Product Change Notification

113444 - 00

Change Notification #: 113444 - 00
Change Title: Intel® Server System P4308CP4MHGC
PCN 113444-00, Product Design,
Updated BIOS/ME/BMC/FRUSDR Firmware
and Label
Date of Publication: November 19, 2014

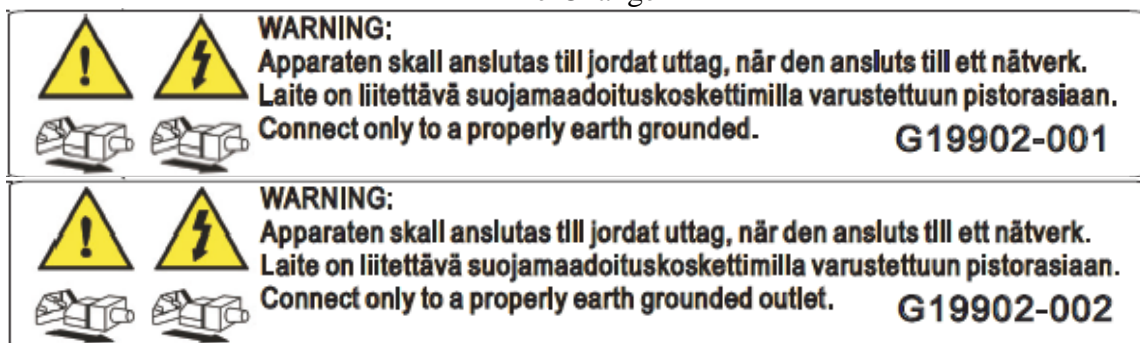
Note: Customers can identify the changes above from the system outer box where a green sticker "V2" is attached. Please see the picture below as an example. The label below is a representation for example purposes only. An actual label will reflect correct product data.
